Appendix H

Royal Agricultural Society of NSW Position Paper

PLR Stage 2 (the project) will assess the interface between the project and SOP event operational requirements in further consultation with Sydney Olympic Park Authority (SOPA). This document focuses exclusively on the interface between the Royal Agricultural Society of NSW (RAS) and the project.

Figure 2 Sydney Olympic Park internal roads

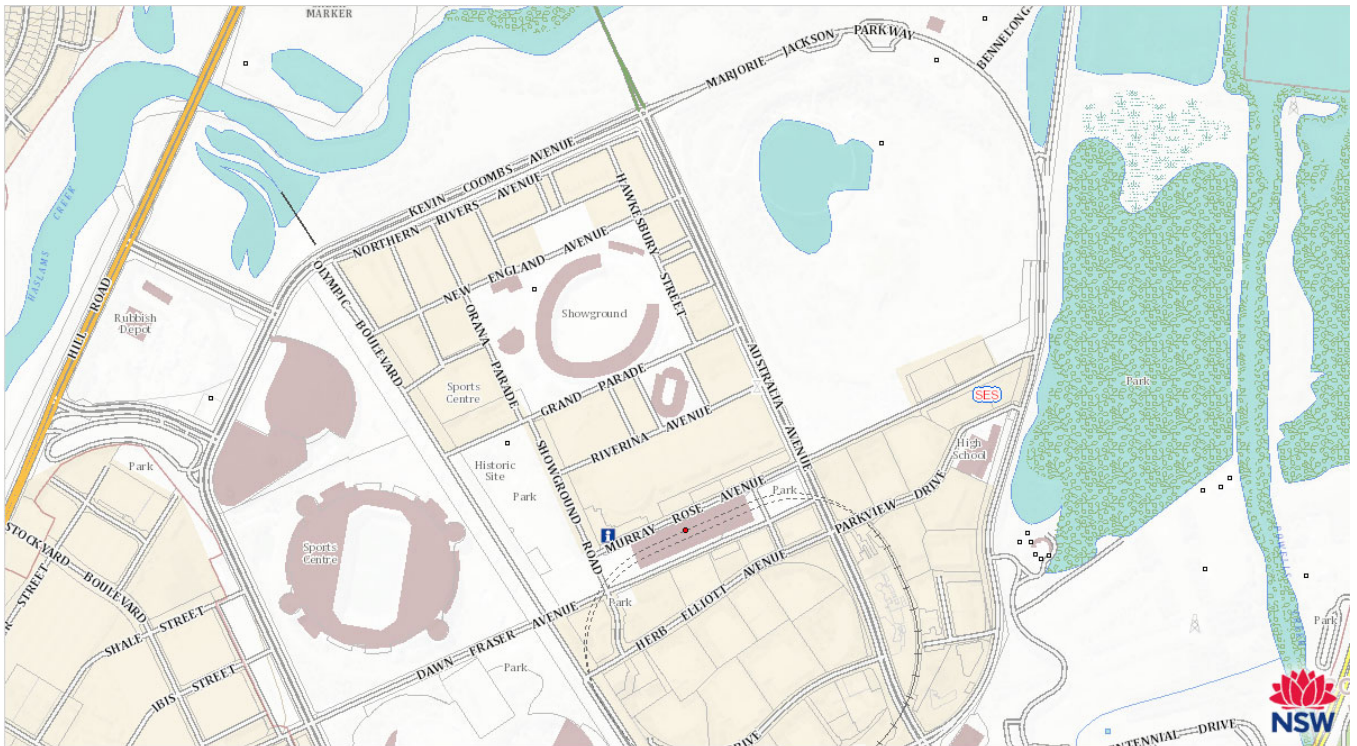
RAS has a long-term lease with SOPA (99 + 99 years) for the use of Sydney Showground Precinct and several other sites within SOP, whereby they organise and operate such events. RAS manages the Sydney Showground Precinct internal road network and has exclusive use of sites within SOP for Carnival Rides, livestock trucks, exhibitor, staff and contractor parking and equipment storage during the SRES.

Figure 4 Sydney Olympic Park RAS requirements map 2 – Hill Rd and P5 Car Park

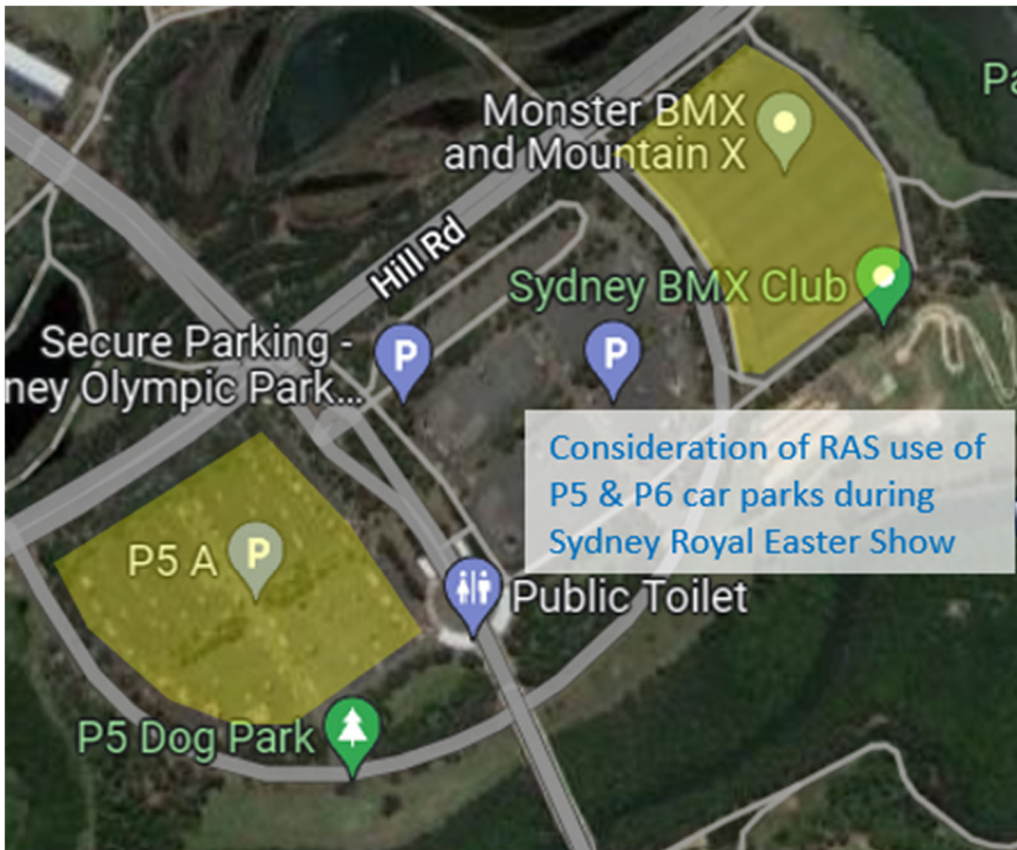
The figures in the following pages document precinct functionality and land use requirement comments from RAS within SOP and the Sydney Showground Precinct.
